2095 Dilworth Road, Kars, ON

Servicing Options and Conceptual Stormwater Management Report

**Reference: 2095 Dilworth Road
Response to City Technical Review Comments
City File No.: D02-02-24-0029
Novatech File No.: 123081**

**CONSTRAINTS AND
DEVELOPMENT AREA PLAN**

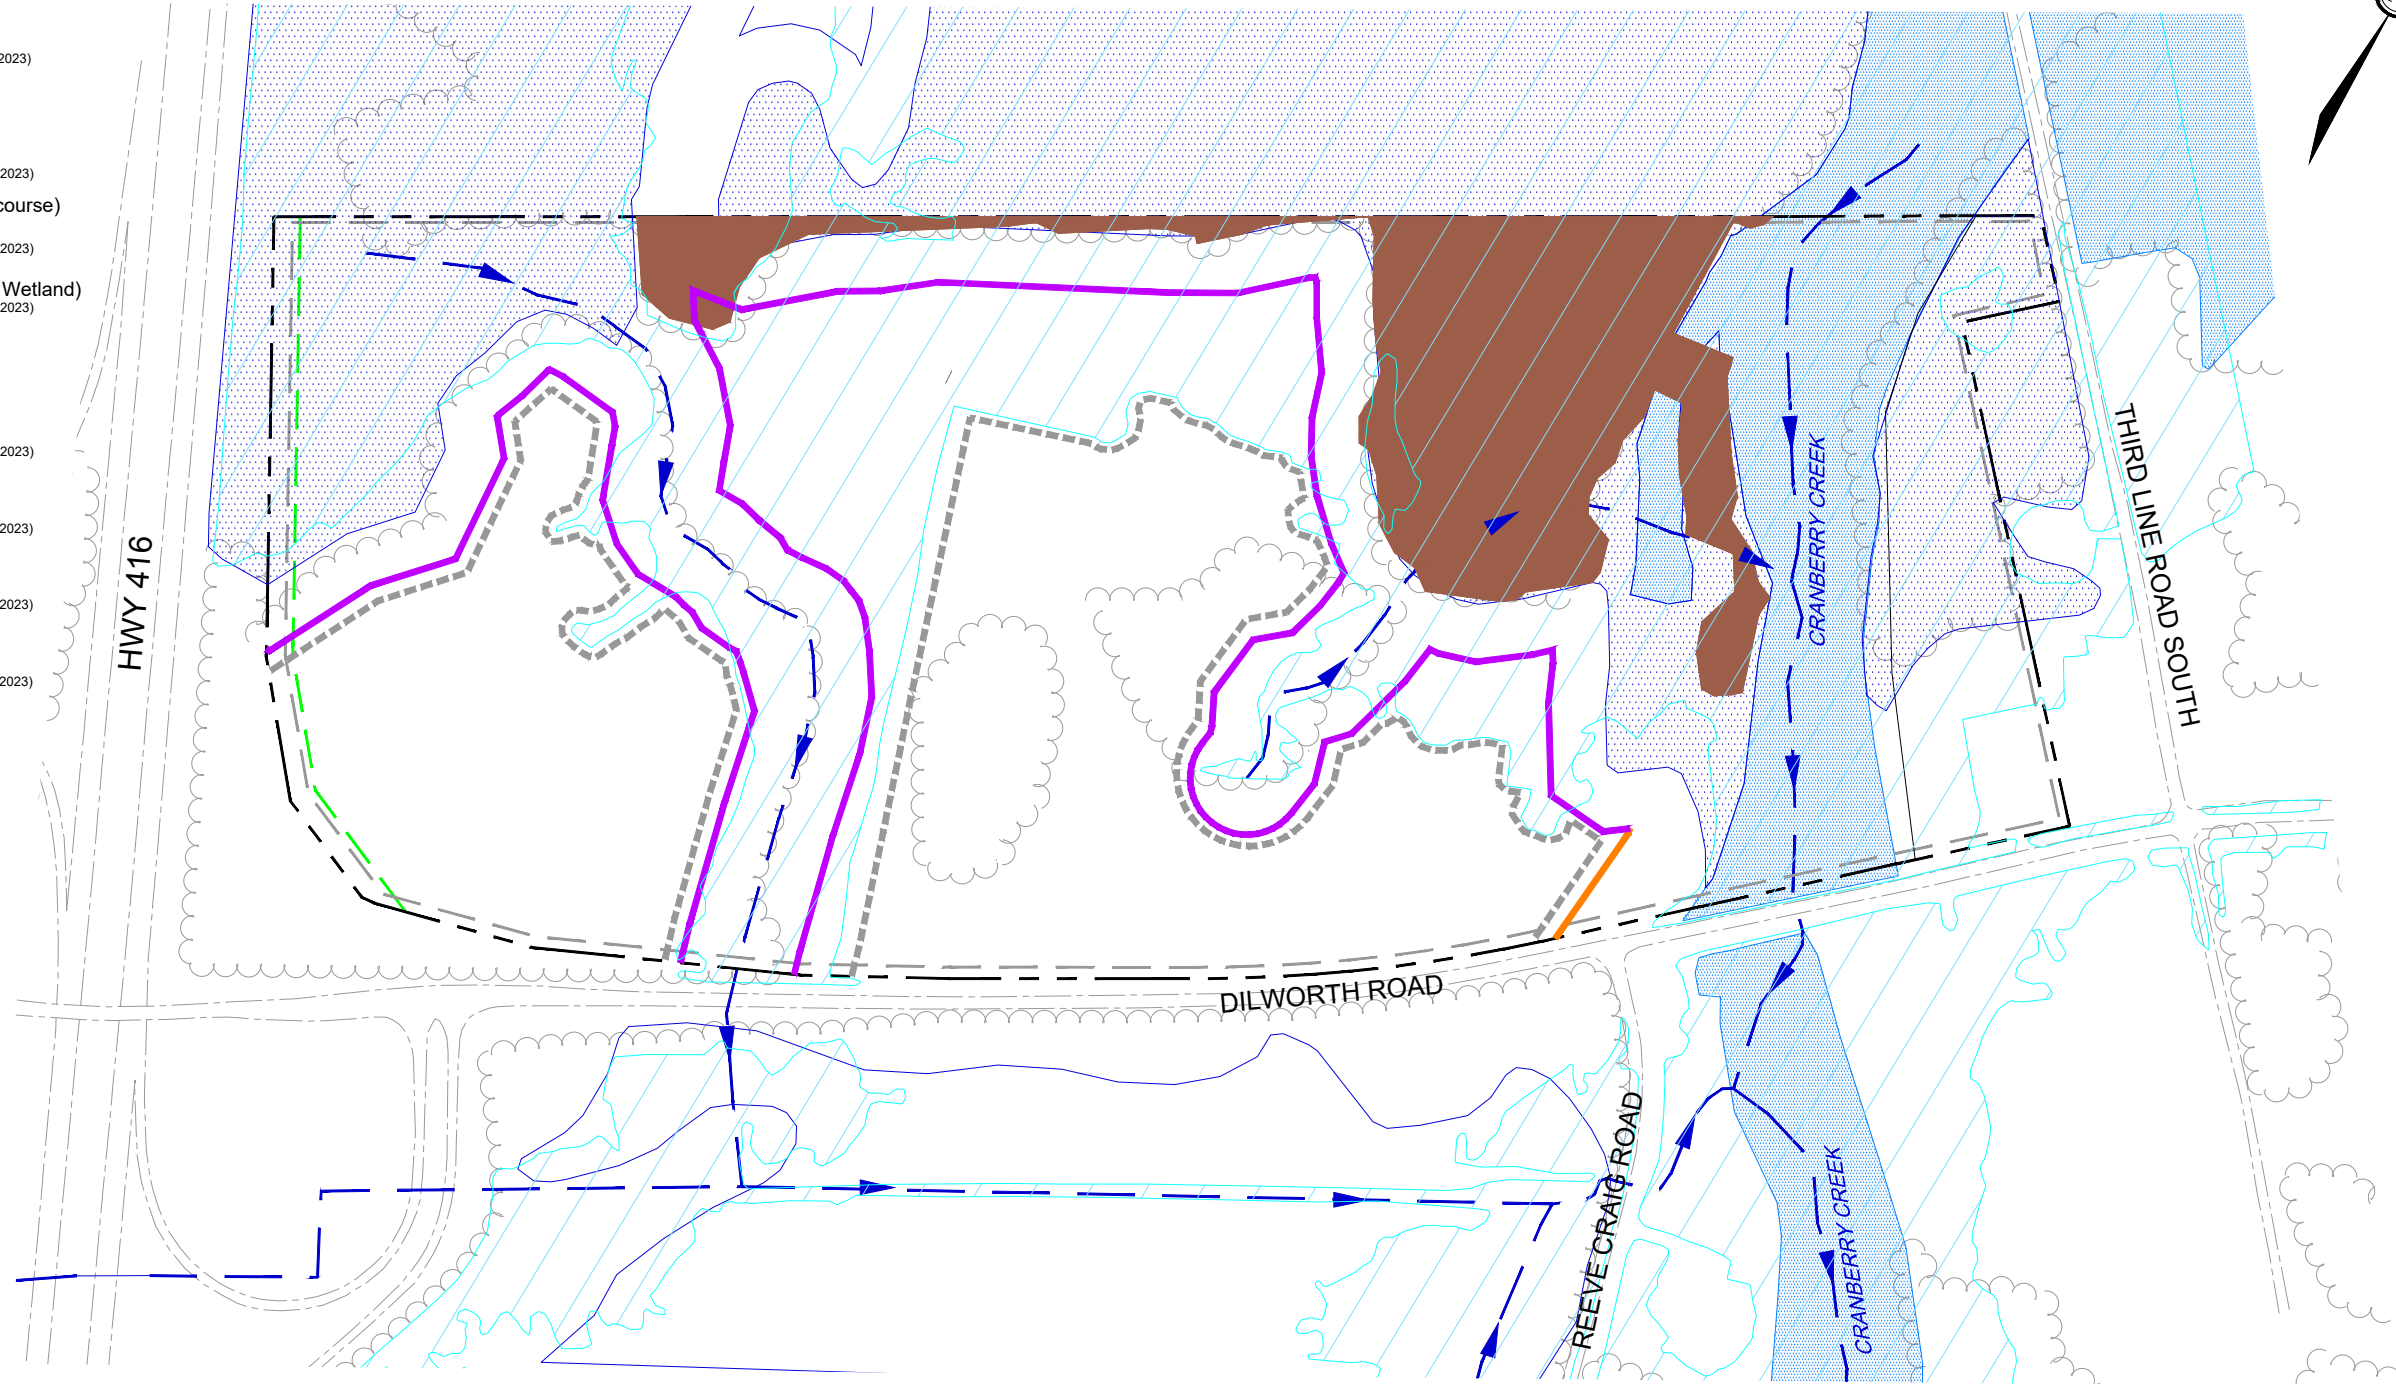
10. Figure 3 of the report only shows directions at the outlet points. The figure should be revised to show complete overland stormwater flow directions. **This comment was not adequately addressed in the report.**

DATE SEPT 2026 JOB 1253081 FIGURE SWM - PRE

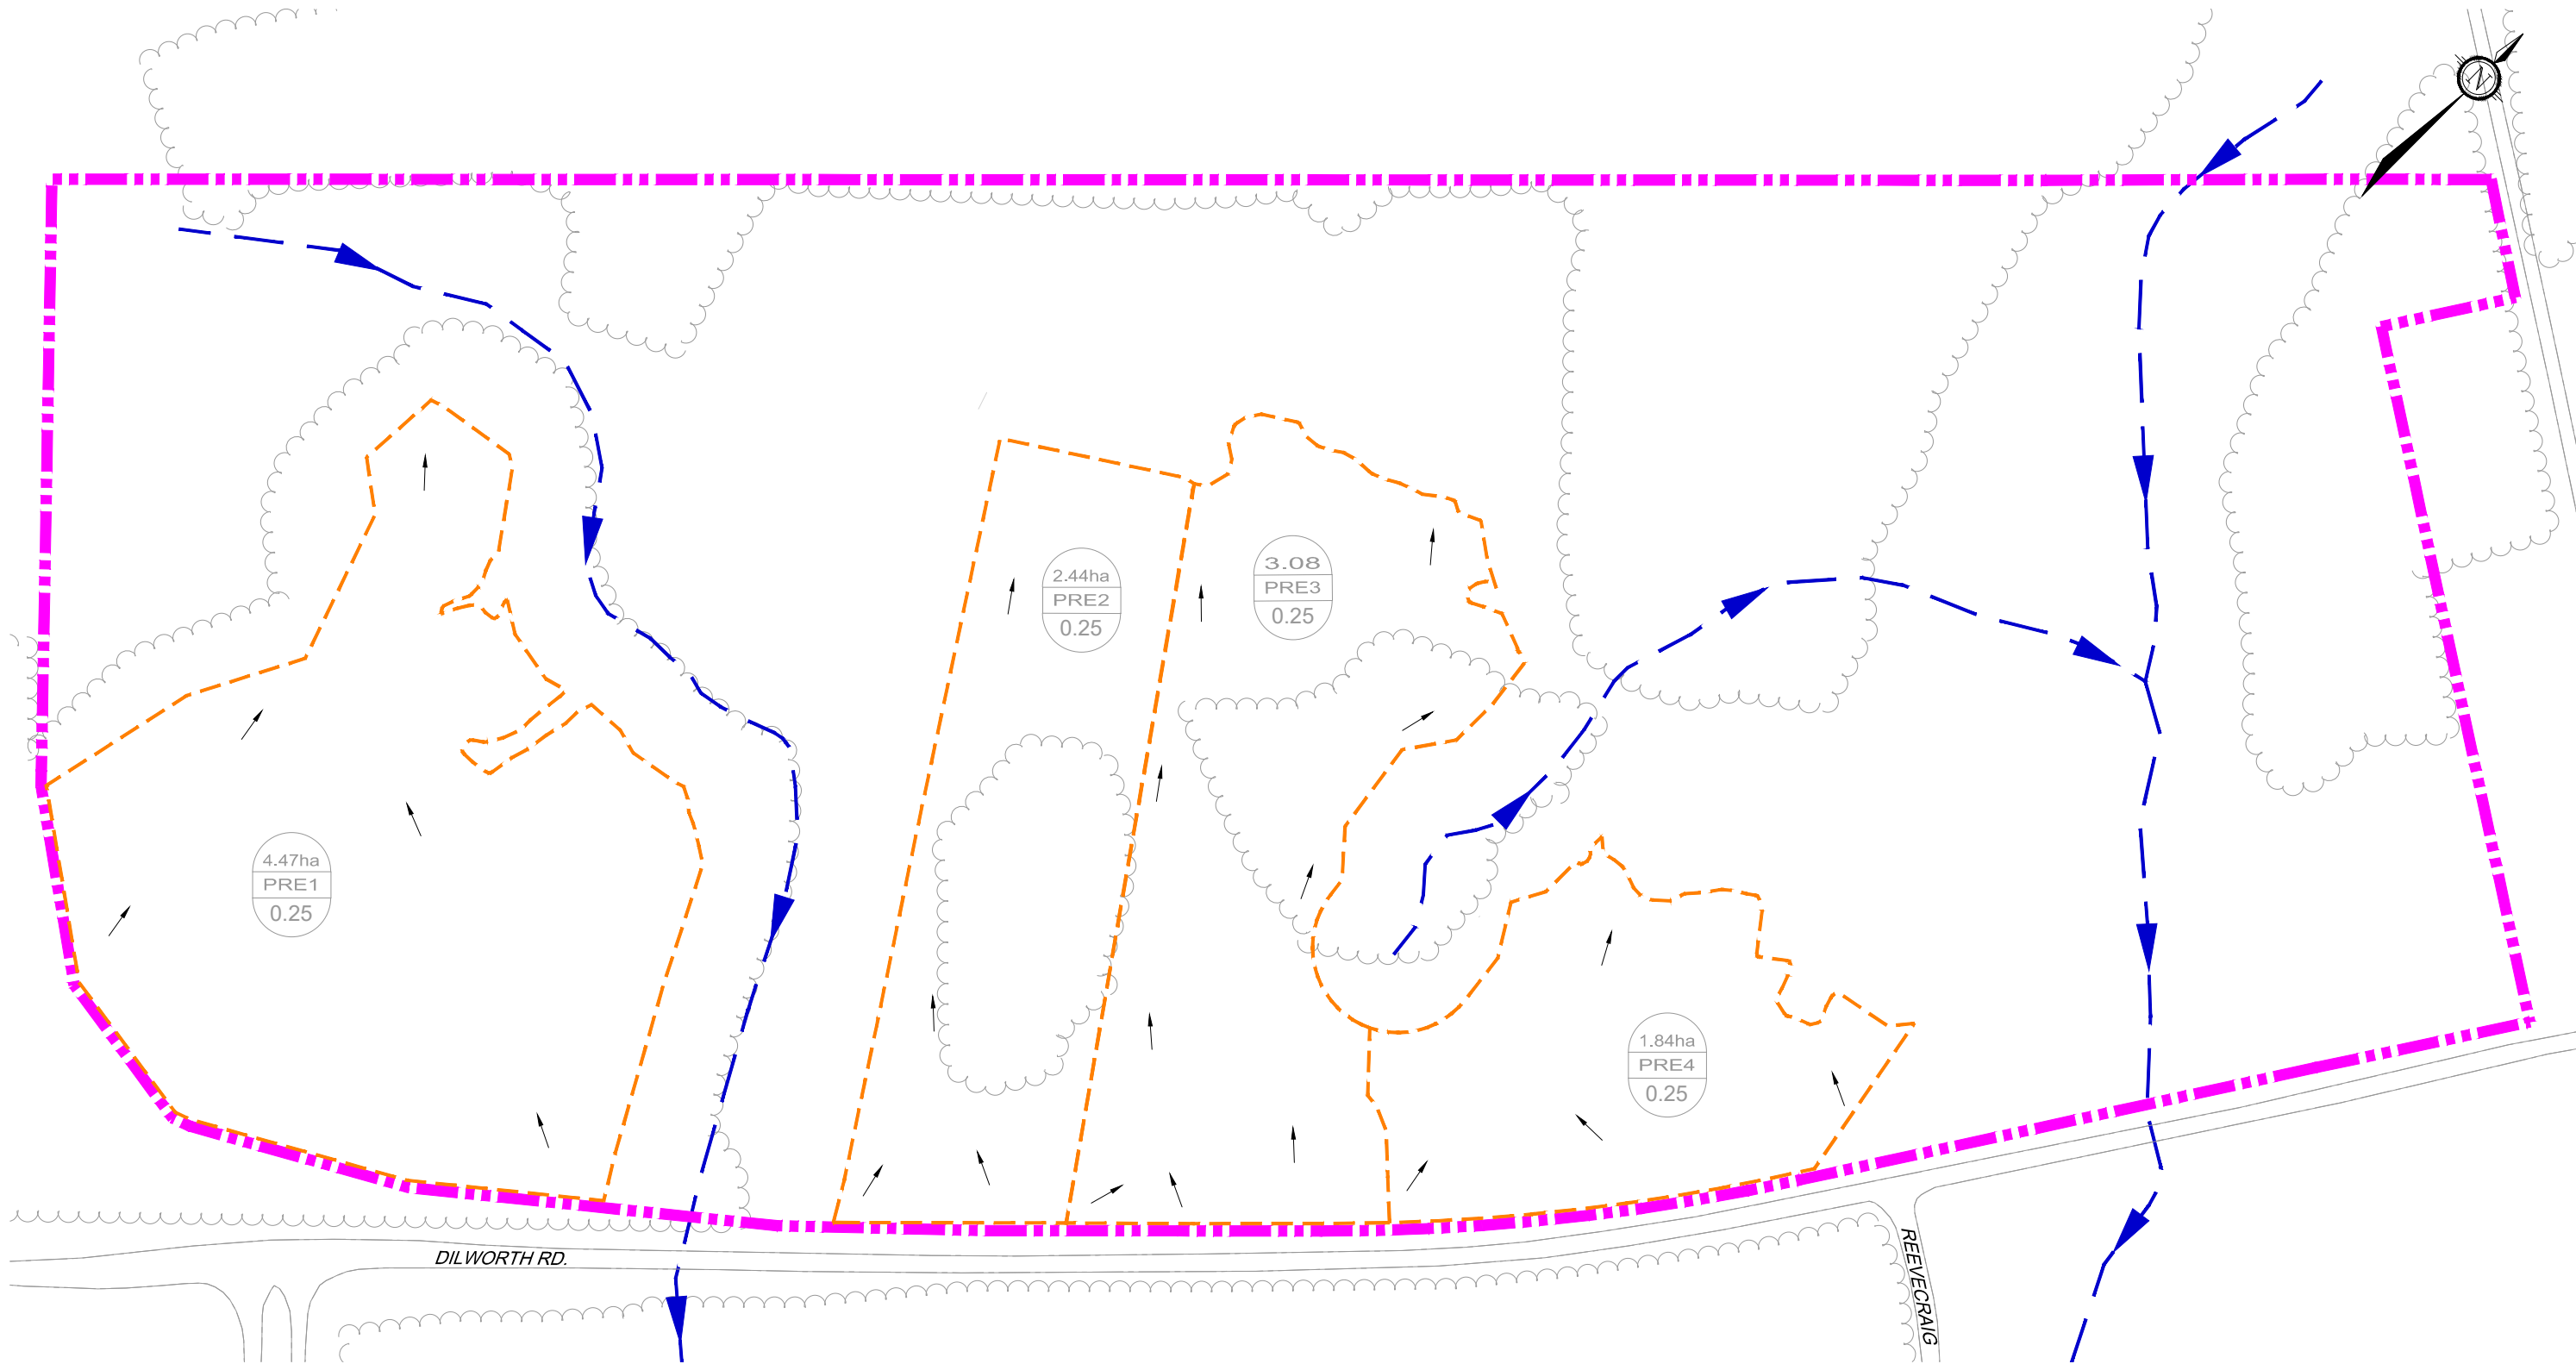
The previously-provided drainage pattern was removed from Figure 3; however, the matter of drainage pattern is still not clear. The drainage pattern arrows shown in Appendix SWM-PRE plan indicate that the MTO property is likely draining, across the property line, to the area PRE-1 (via northwest corner?).

FIGURE DSK-1

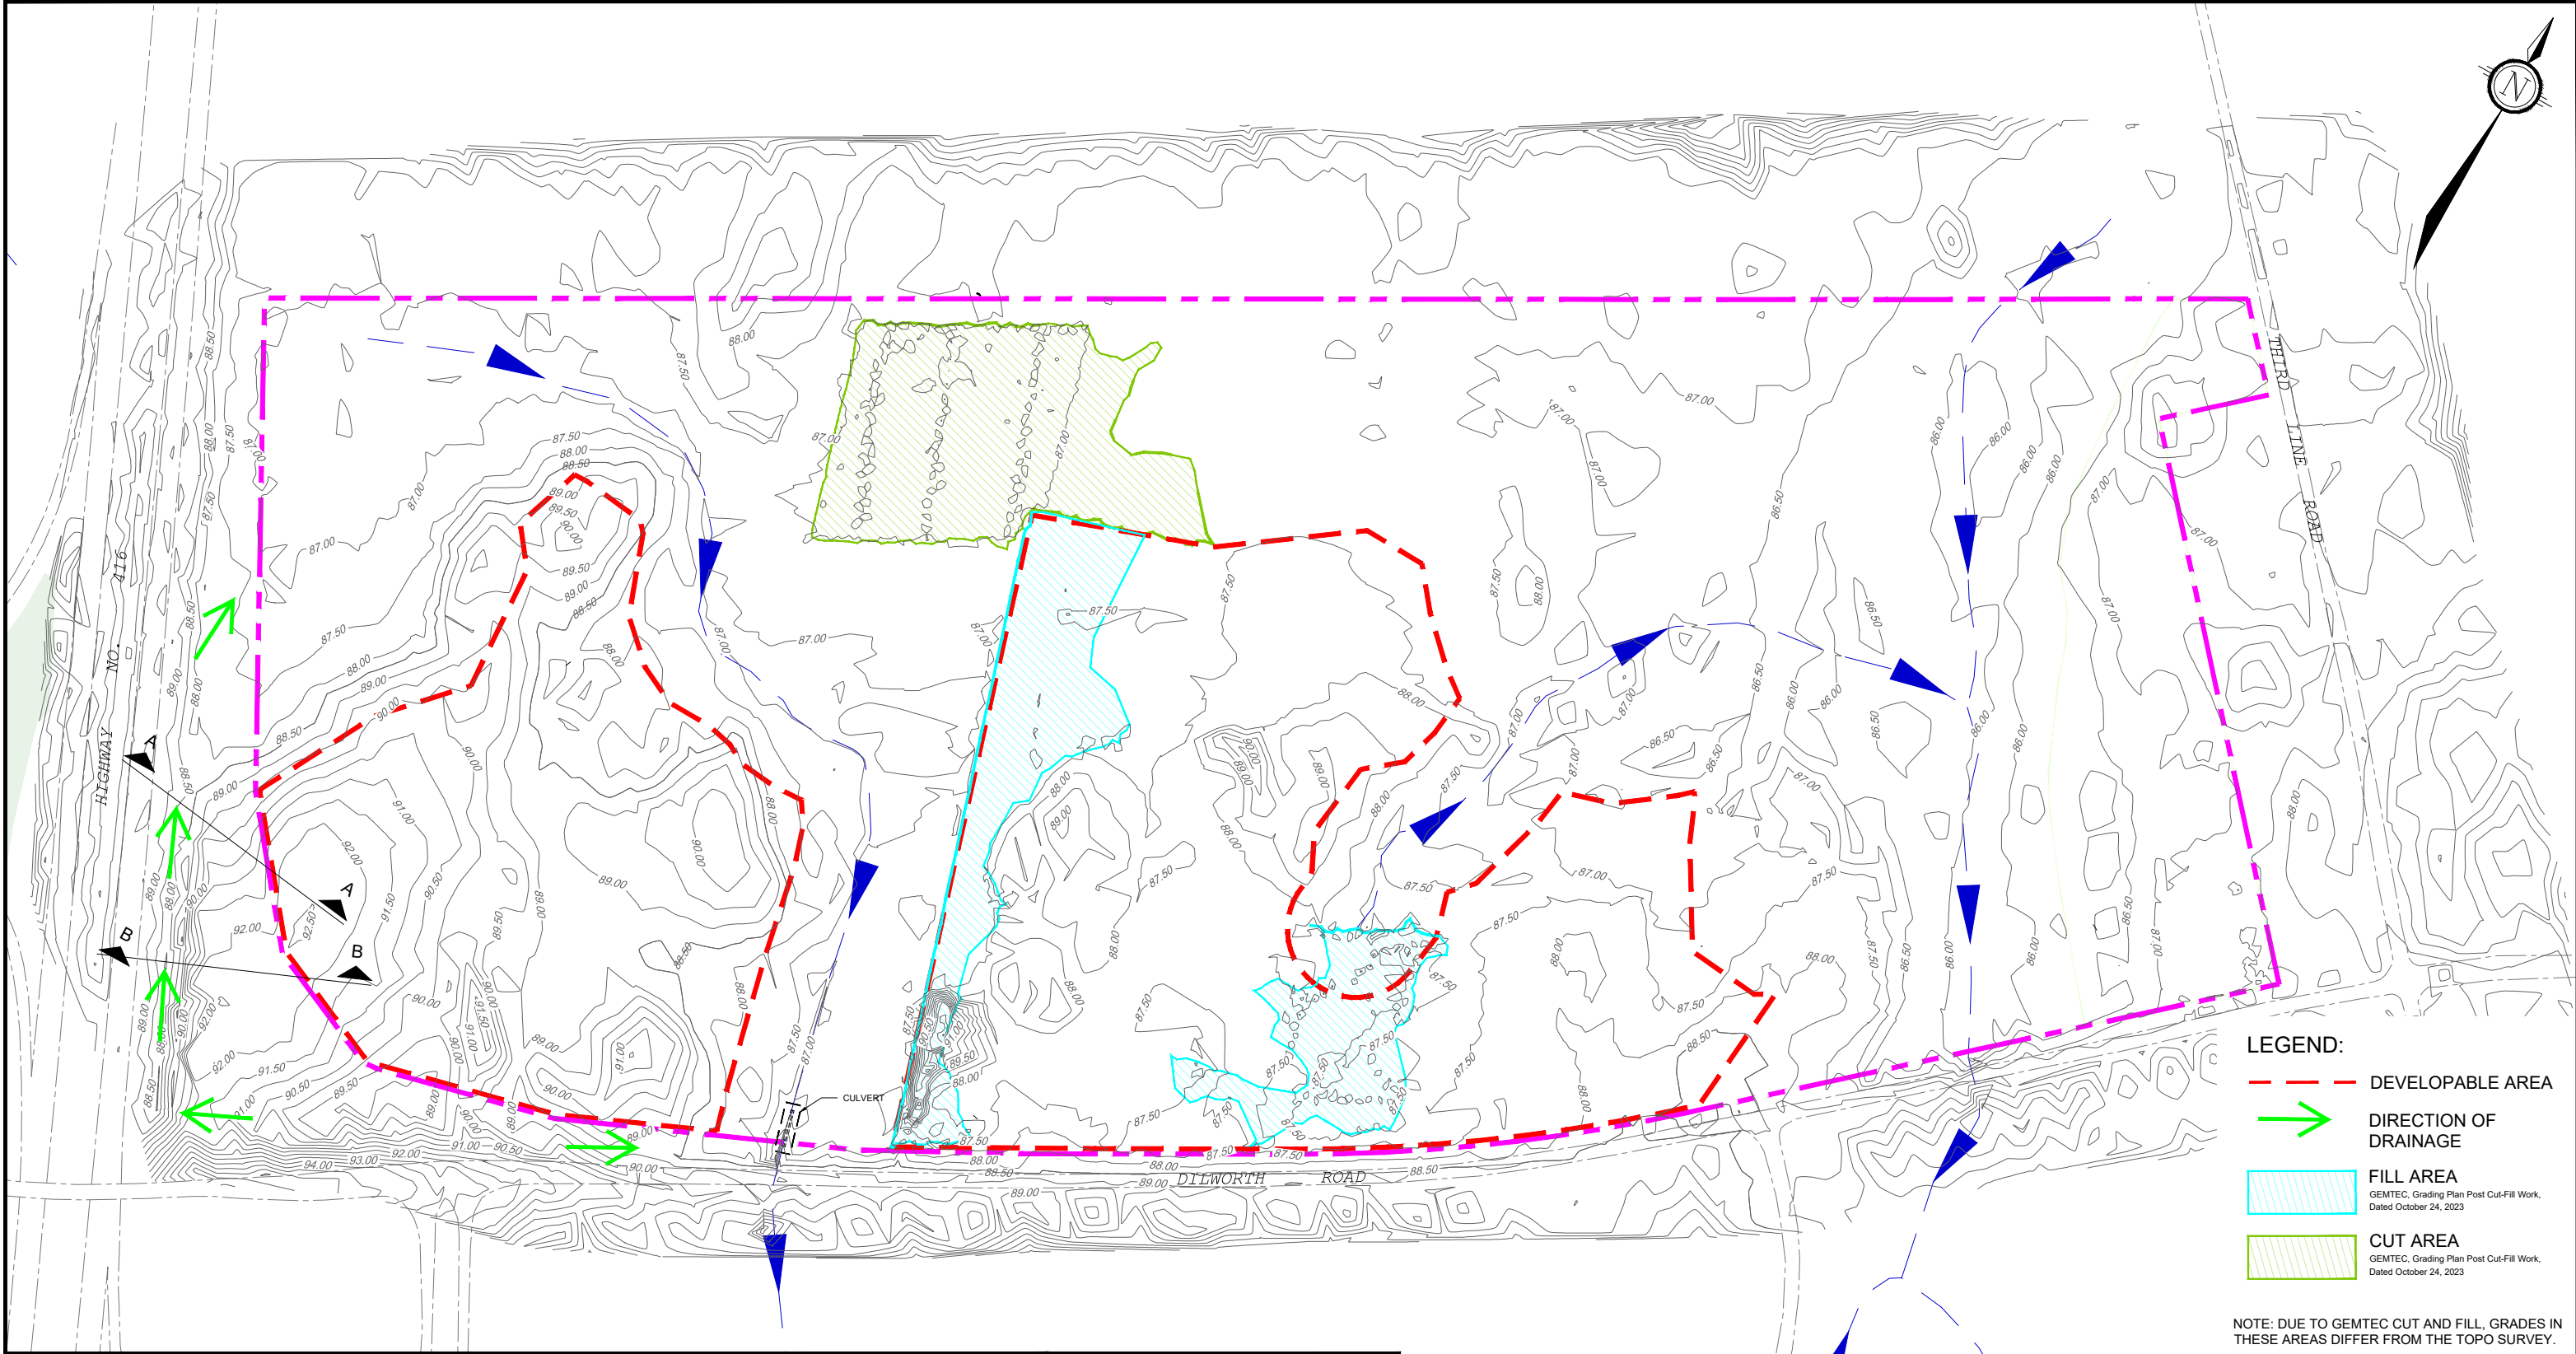
9. Aerial imagery from 2019 shows potentially existing drainage path from Highway 416 right-of-way, through the site, towards the on-site watercourse site. Change in the existing condition though potential development of the area designated as Area 1 may have an impact on the Highway 416 drainage.

The email correspondence with the MTO is noted; however, maintaining stormflows from the adjacent properties including from MTO's Highway 416 lands, among others, should be analyzed and specifically discussed in the report. The Pre/Post Development Drainage Areas Plan, included in Appendix B, does not appear to include any potentially existing off-site tributary flows, which need to be accounted for. **This comment was not addressed in the report.**

Please account for offsite flows and show the directions of surface runoff on the properties directly adjacent, which might contribute to SWM (Ponds A and D) on the site under consideration. Some flows might also be entering area PRE-4 across the property line. The report needs to be clear in establishing if external flows are applicable or not.

4. Regarding the potential offsite flows towards the future development areas, comment, previously related to Figure 3, the Novatech response mentioned that offsite flow directions were shown on a DSK-1 Plan. The mentioned plan was not included in the last submission. Please provide the DSK-1 Plan in the report. **Novatech Response: The figure will be included in report appendices with a copy of the response letter.**

Novatech Response: It is our opinion that the highway drainage drains along a roadside ditch towards the wetland area and around the subject site. Please refer to attached figure DSK-1 that shows contour mapping. We have added drainage direction arrows to show the flow path of the highway drainage. We have also shown two cross sections which shows a low point between the highway and the site forming a drainage ditch. The highway drainage does enter the wetland area and follows the tributary and therefore, should be included in the drainage area for the culvert crossing Dilworth Road (as included in Gemtec's culvert calculations). The drainage does not affect the developable area of the subject site. Further review will be done through later Site Plan Application that will be required to lift the Holding Zone.

Novatech Response: Direction of drainage arrows for adjacent property have been added to the attached DSK-1 which shows that drainage from the adjacent property drains towards the tributary and not ponds A and D.
